**Northeast Ventnor Redevelopment Plan
Amendment No. 1 (Ventnor Avenue - C/MU Zone)**

**Ventnor City, New Jersey
April 11, 2018**

Source: Urban Engineers

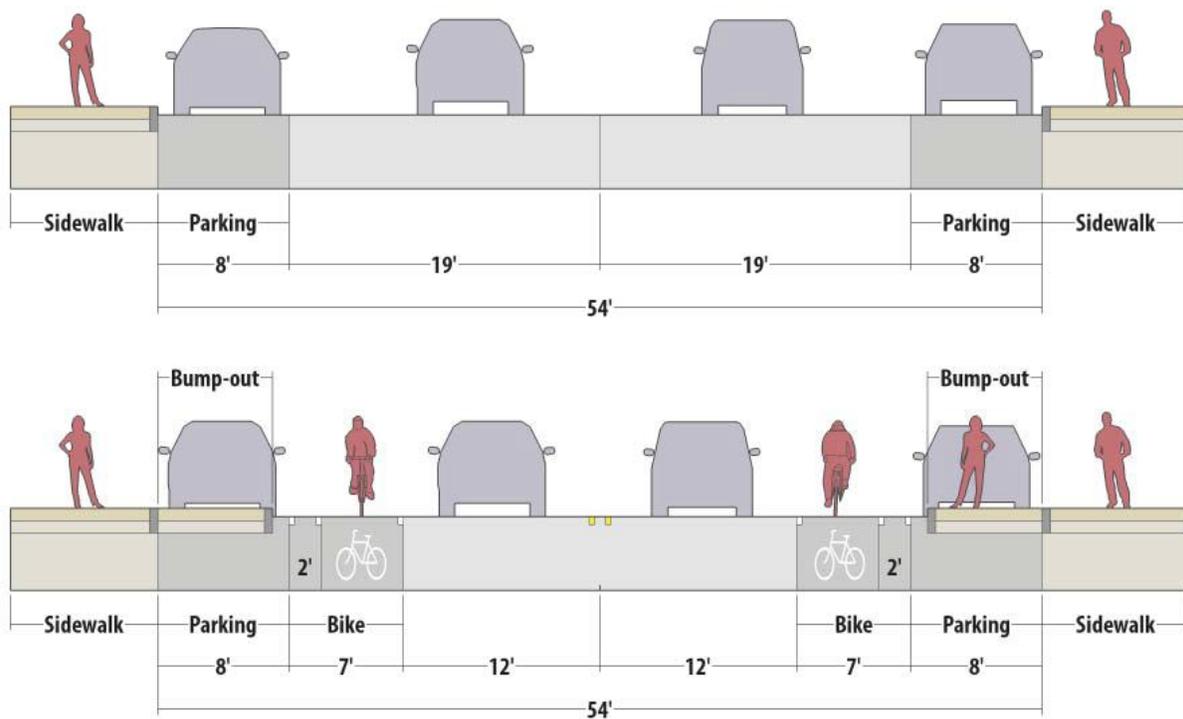
Existing: *Ventnor City maintains an 80 feet right-of-way along the portion of Ventnor Avenue that traverses the NVRA. In the interest of traffic calming and pedestrian safety, the cartway width within the right of way should be reduced to 40 feet. The reduced cartway will extend along Ventnor Avenue between Little Rock Avenue and Jackson Avenue. An attendant increase in sidewalk widths up to 20' is also recommended. An 8 feet wide parking lane shall be*

maintained within the cartway to allow for on-street parallel parking. All improvements within the right of way should be completed in accordance with the design standards contained herein.

Proposed: As proposed, the 24 feet cartway shall remain. However, 7 feet bike lanes (inclusive of a 2-foot buffer) shall be located between the cartway and an 8 feet parking area, as seen in the following image. The total cartway width shall be 54 feet instead of 40 feet, with 13 feet sidewalks instead of 20 feet. Allowances shall be made for secondary higher sidewalks for building floodproofing requirements.

The proposed streetscape cross-section shown previously provides ample room for cars with safe passage for bicycles and pedestrians.
